Service Information bulletin	Number 4	
date	16-11-2007	
product	Ride On	
subject	Collision Gas spring	
Serial numbers	500 - 799

Collision between ball joint from gas spring and fixation mushroom at all models:

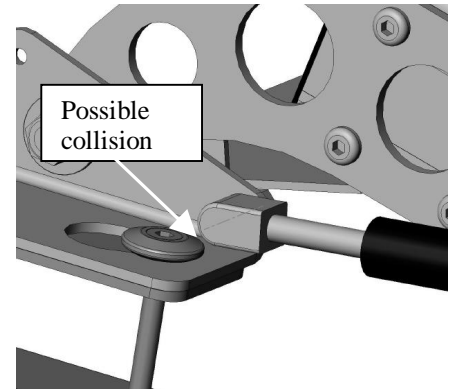
The ramps in this batch have fitted gas springs from a different supplier. This caused a possible small collision between the ball joint from the gas spring and the fixation mushroom.

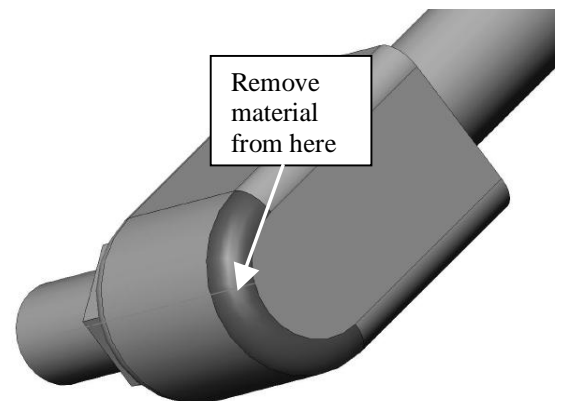
Some times it is enough to open the ramp a few times to remove some plastic material from the ball joint. However this can in the worse case lead to breaking the ball joint. Therefore it is recommended to remove a little material from the ball joint in the area as shown in this picture.

Removing the material can be done with the gas springs fitted on the ramp, when the ramp is removed from the vehicle, with a grinder or rasp.
